Calais at Pelican Bay

Project Management Report 19 – Building F

RE: Scope of Work Updates and Revisions – Unit F-301, Building F Post-Tension Cable Repairs

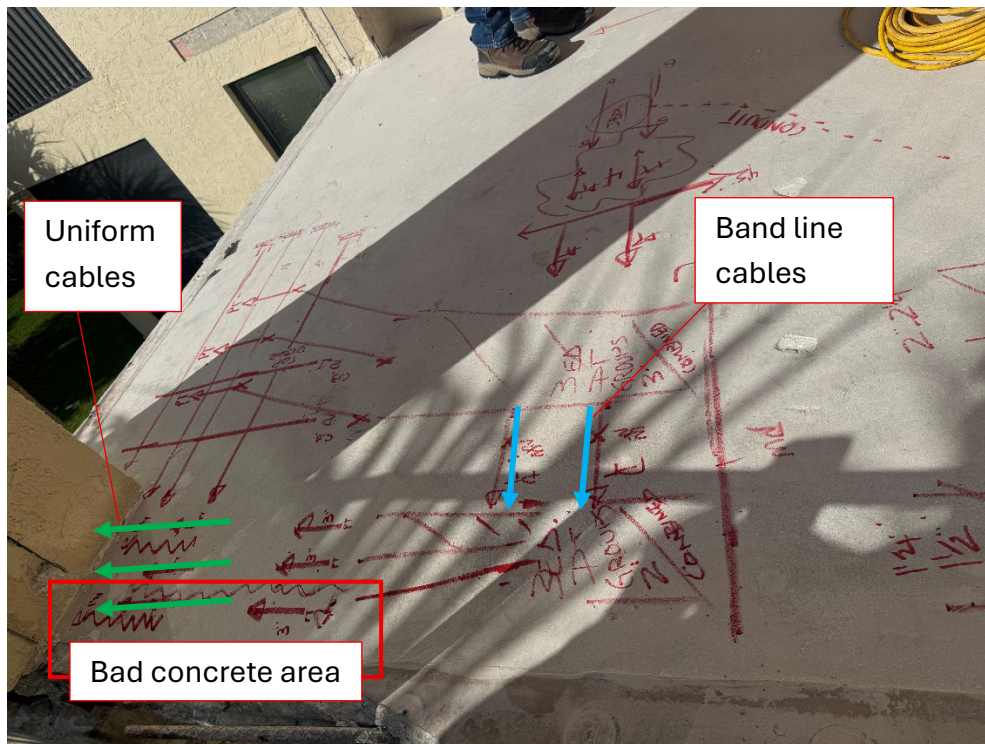
Following exploration of the **remaining 2 uniform cables**, field investigation has revealed the same complexities encountered with the band line cables:

- Insufficient clearance for locking off with a chuck splice to perform partial repairs.
- High concentration of reinforcement bars in the affected area, adding structural complexity.
- Standard repair procedures would require extensive shoring through the units.

During the process of full cable replacement and preparatory work at the slab edge of Unit F-303, additional structural concerns have been identified:

- Corroded hook reinforcement bars at the slab edge.
- Slight corrosion on the uniform PT anchors.

- Strong reflections often signifying **delamination within the concrete**.
- The affected area appears to extend beyond the first identified uniform PT cable.
- Similar complexities to those found in Unit F-301 are present.

In consultation with the PT Specialist during today's on-site meeting, **full cable replacement for the remaining 2 uniform cables** has been determined as the best course of action.
